UNITED STATES  
NUCLEAR REGULATORY COMMISSION  
WASHINGTON, D. C. 20555

APPLICANT: Consumers Power Company  
FACILITY: Midland Plant, Units 1 & 2  
SUBJECT: SUMMARY OF JANUARY 27, 1981 VISIT TO OBSERVE CRACKS IN CONCRETE RING FOUNDATION OF BORATED WATER STORAGE TANKS

Subj: Trip Report - Site investigation of cracks observed in the foundation of the borated water tanks at Midland Plants Units 1 and 2

FIG 1-A BORED WATER STORAGE TANK

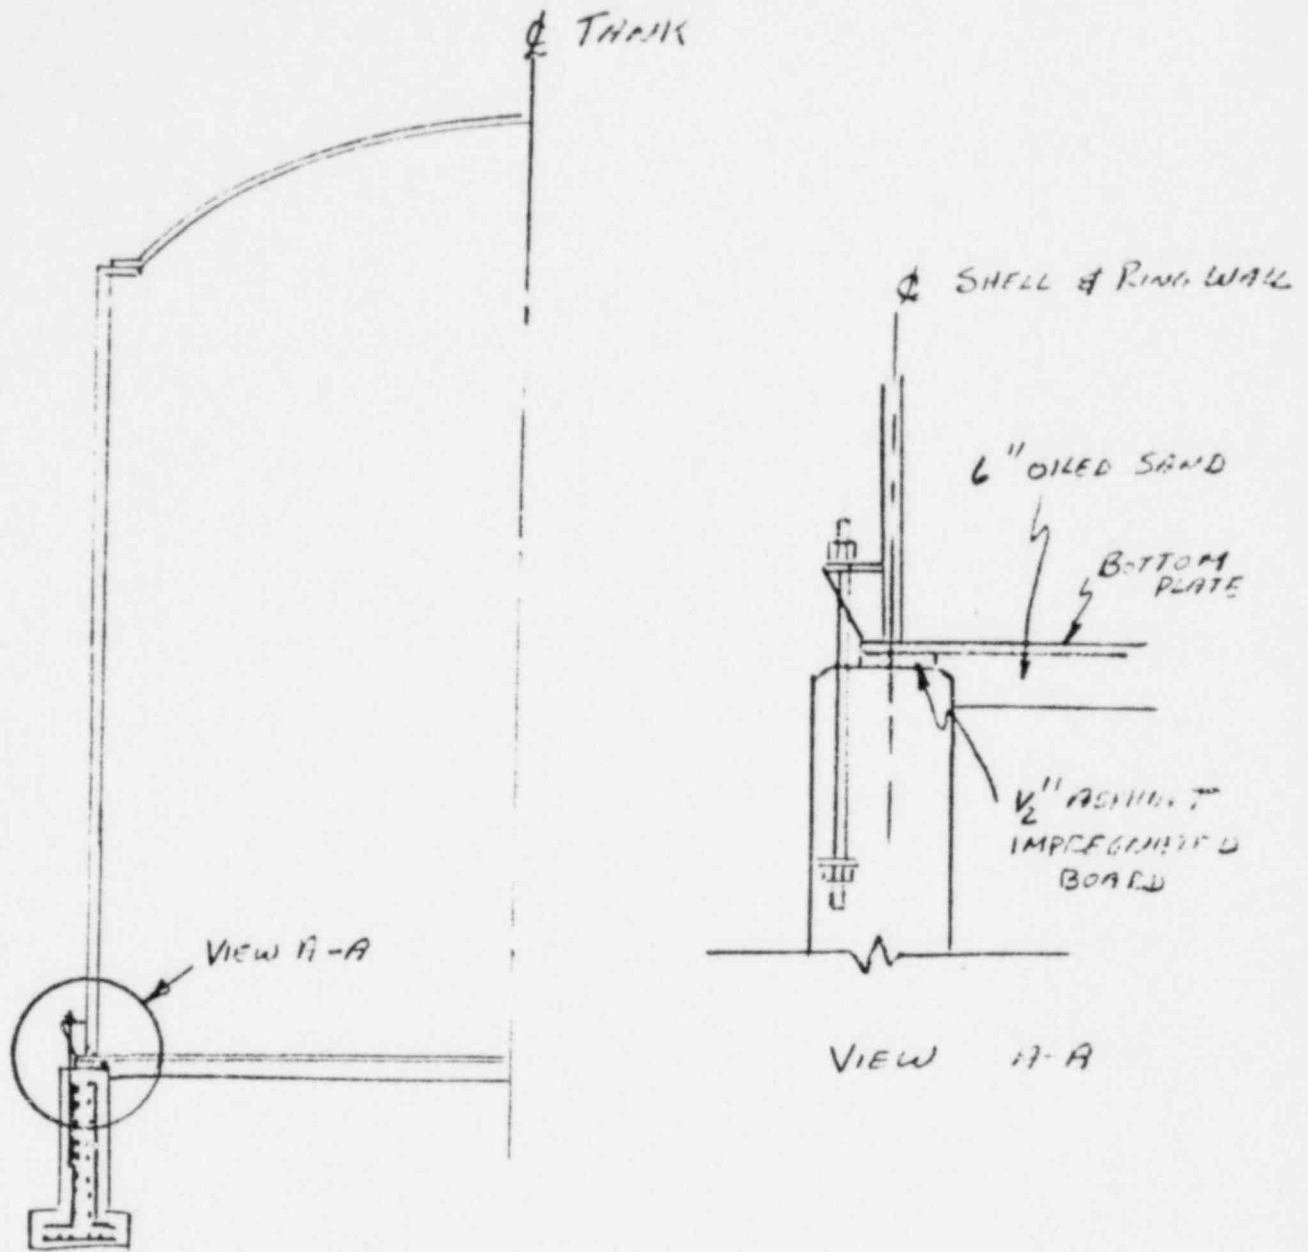
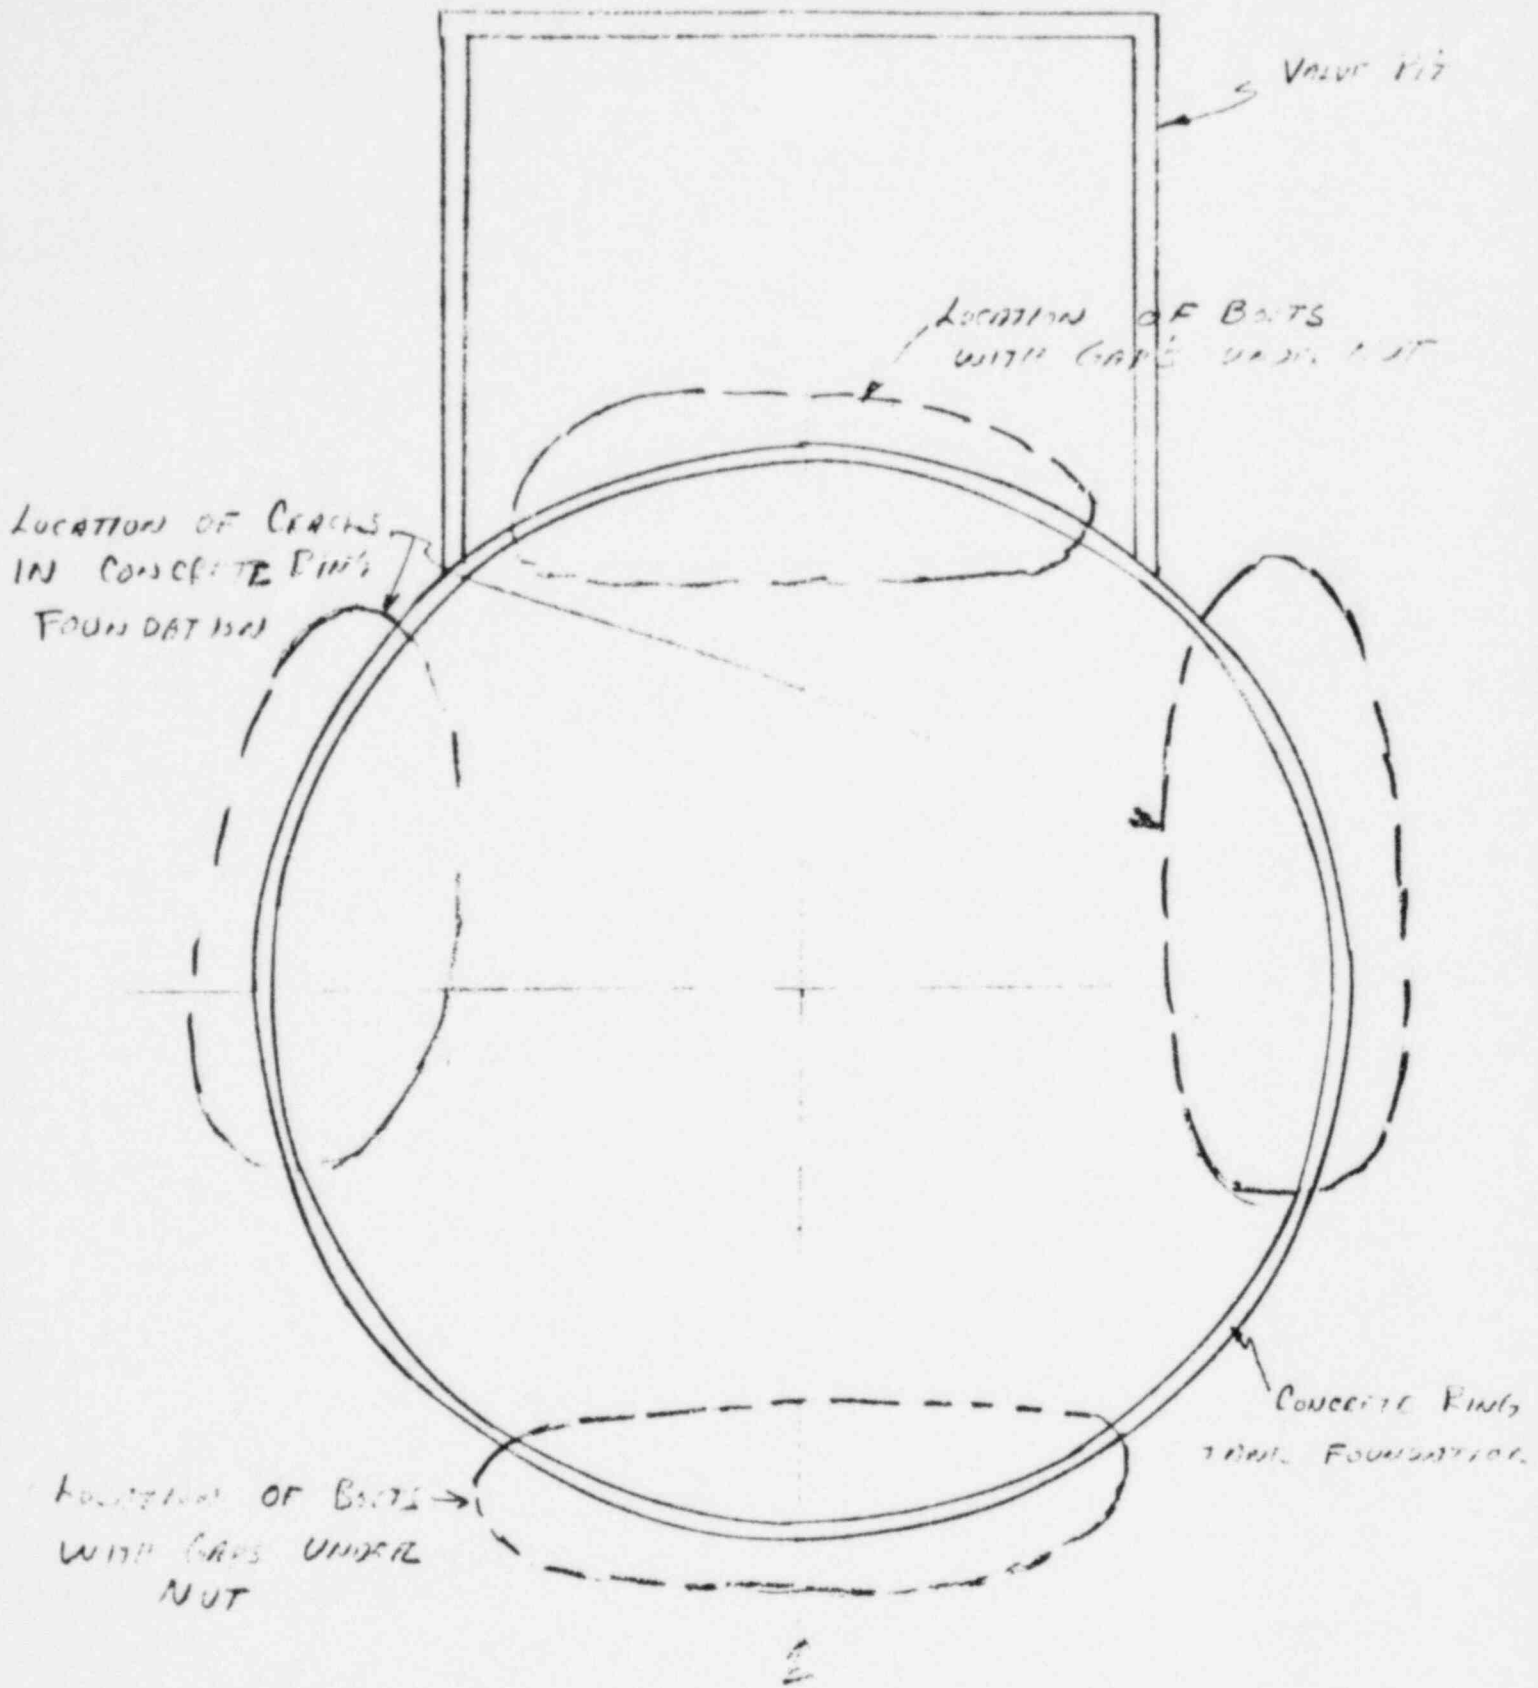
a. Cracks (Max  $\approx$  .060 inches) in the concrete ring foundation on both sides of the valve pit. (See Figure 1-A&B).
